CSET Busway Extension - Grange Farm

Technical Note

Project:	CSET Phase 1 – Project Design		
Our reference:	100119844 CE03	Your reference:	-
Prepared by:	Chris Mason	Date:	26/09/2025
Approved by:	Michael Payne	Checked by:	Stuart Croucher
Subject:	CSET Busway Extension to Grange Farm Review

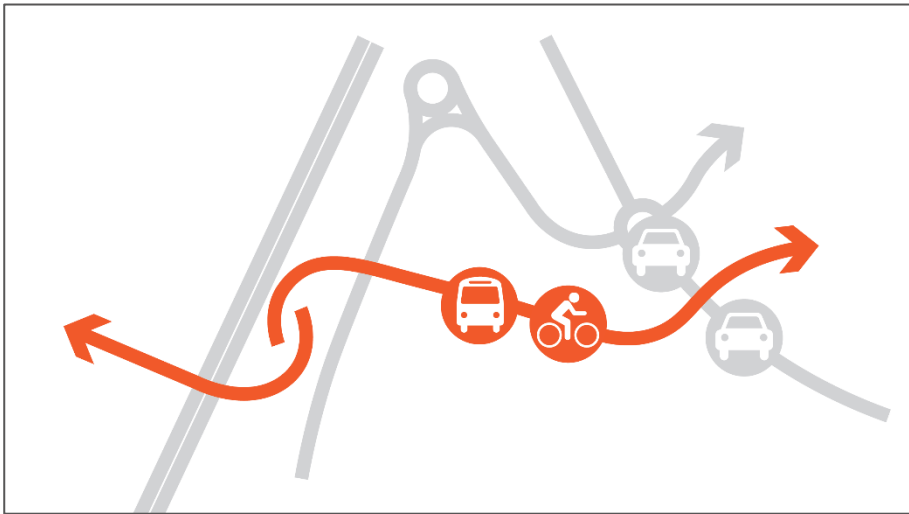
Our initial analysis of the above proposal identified the following potential issues:

Busway turning radii: How the route curves between the A11 and Newmarket Road; there are options for the CSET busway which might need wider turning radii than shown here.

Newmarket Road junction: How the route crosses Newmarket Road. If at grade, the junction created may not be acceptable as the busway is not close to perpendicular to the Newmarket Road alignment.

A1307 signalised junction: The proposed busway will require a signalised junction crossing of the A1307 which will need to be considered when any potential new main vehicle access to the Grange Farm site is being developed.

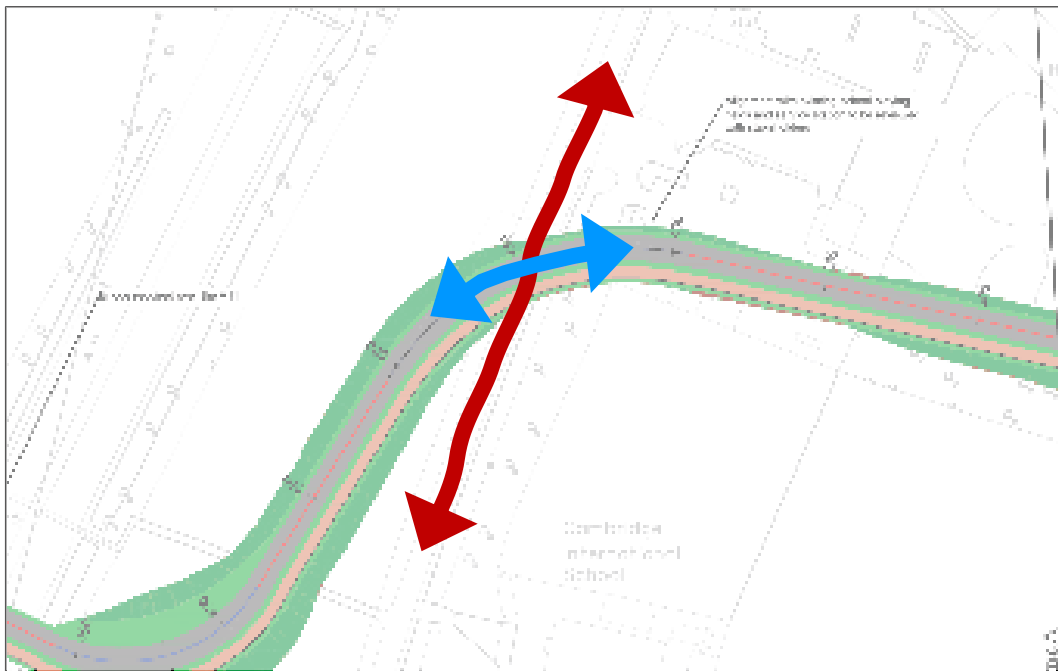
The first issue when reviewing the original 'Blue' route proposal was how the busway runs from the bridge over the A11 and then comes to meet with Newmarket Road at grade.

In order to allow the buses to travel at 60kph a 64m curve radius is required, according to Manual for Streets 2.¹ The original option was tested with this standard and it was found that there is not sufficient space for the two curves of 64m required to meet with Newmarket Road at grade.

This challenge means that either a single turn is utilised, and the route west of Newmarket Road is abandoned, or the 'chicane' is achieved by use of a pair of signalised junctions on Newmarket Road. These are discussed in more detail below.

i) Double Junction

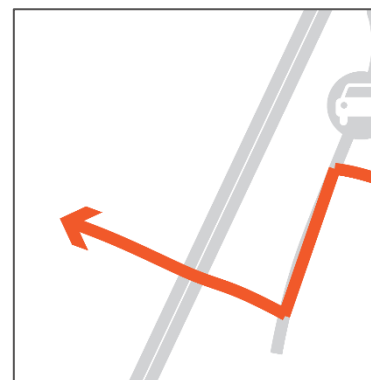
The proposed junction where the busway crosses Newmarket Road is non-compliant (see below). Ideally the busway would operate perpendicular (or close to) the existing road, creating a crossroad junction.

In this option the busway would cross the A11 and travel straight ahead towards Newmarket Road. The busway will then briefly join Newmarket Road via a priority signalised junction for approximately 200m before turning right back onto the segregated busway via another signalised junction.

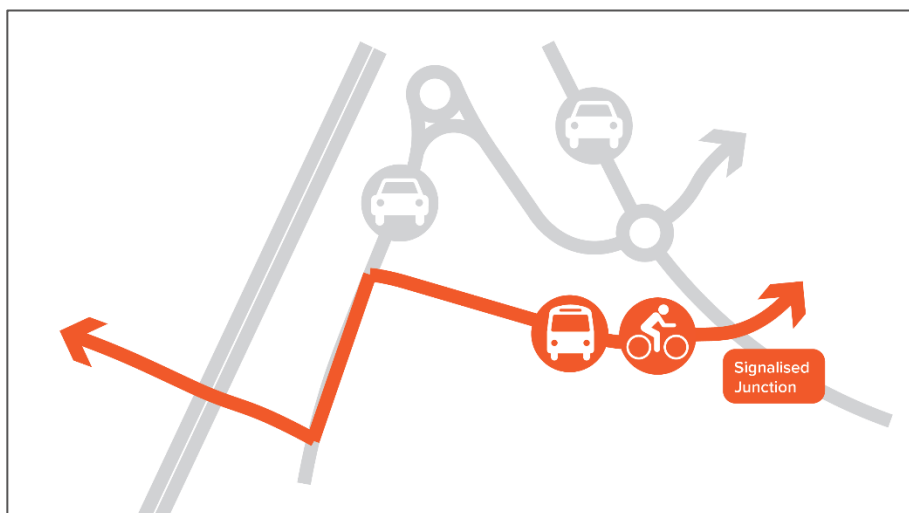
The busway crossing needs to be considered in conjunction with the site access arrangements for the proposed site.

This option proposes to push the crossing further southeast, allowing for a larger gap between the busway crossing and the potential access to the Grange Farm development. This option will need to consider the farmland present to the south. While it is thought that this option could increase the gap by as much as 50 metres, it does not completely remove the possibility of traffic backlogs at the previously proposed roundabout – should an access junction at this location be taken forward.

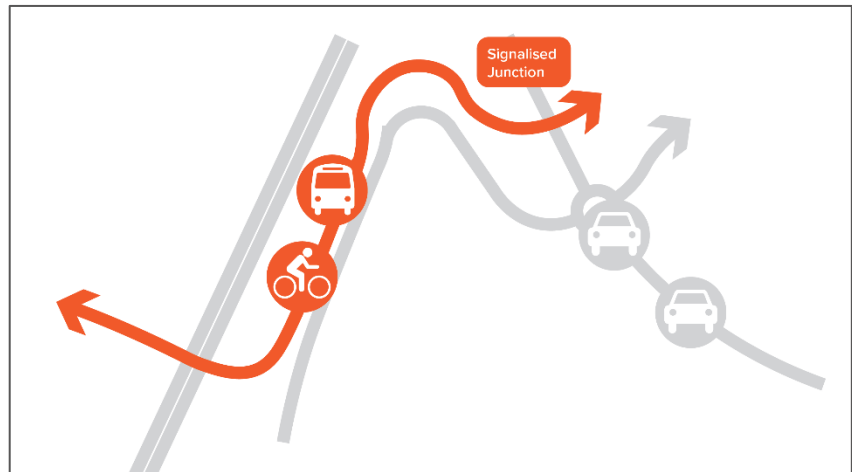
Consideration should be given to the petrol station and hotel that are accessed close to the existing roundabout.

The second option relocates the busway north of the previously proposed roundabout, replacing the redundant existing roundabout there. As noted above, the previously proposed roundabout has no current status and detailed access arrangements for Grange Farm are still to be determined.

The busway crosses the A1307 to the north of the previously proposed roundabout to access the Grange Farm development. As there is some 350m between the A11 junction and the previously proposed new A1307 roundabout, it is easier to create better separation between junctions, reducing the potential for any impact on their functionality, should access to the Grange Farm site remain as originally shown.
